**STAFF REPORT
OF THE PLANNING DEPARTMENT
FOR THE CITY OF BANDON, OREGON**

FILE NUMBER: 21-113

REQUEST: Approval of a Plan Review (PR) to site a new single-family dwelling on property zoned Controlled Development 1 (CD-1) in the City of Bandon

Figure 1 Subdivision Map, *The Moorings*

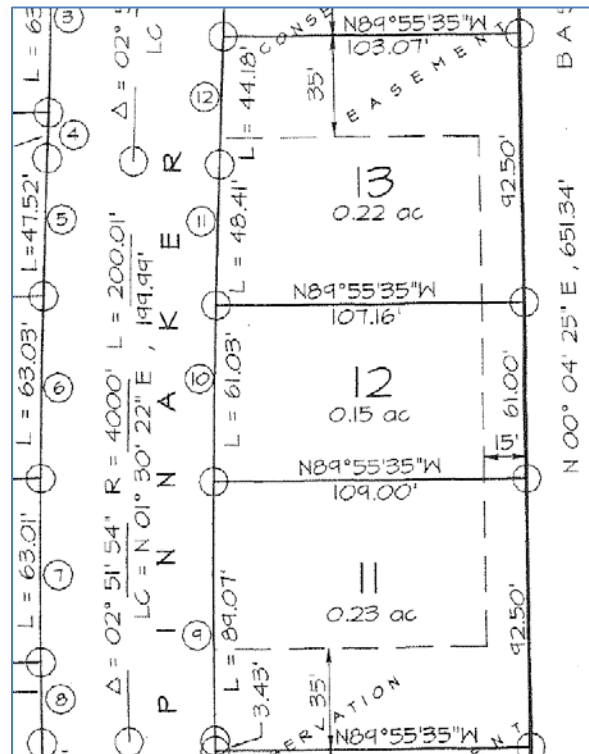
The subject property also contains conservation easements, which were required sites for wetland mitigation for the original subdivision, *The Moorings*. The north side of the property has a 35-foot conservation easement, and the east side of the property has a 15-foot conservation easement. These areas are deed restricted and cannot be built in or dumped in. The subject property is Lot 13, and part of Lot 12, shown below. Lot 12 was divided between Lots 13 and 11 through a "boundary line adjustment" in 2003.

10. No dumping, building, or driving through the conservation easement is allowed, during construction, or after certificate of occupancy. The boundary of the conservation easement must be strung during construction to ensure compliance with this condition.
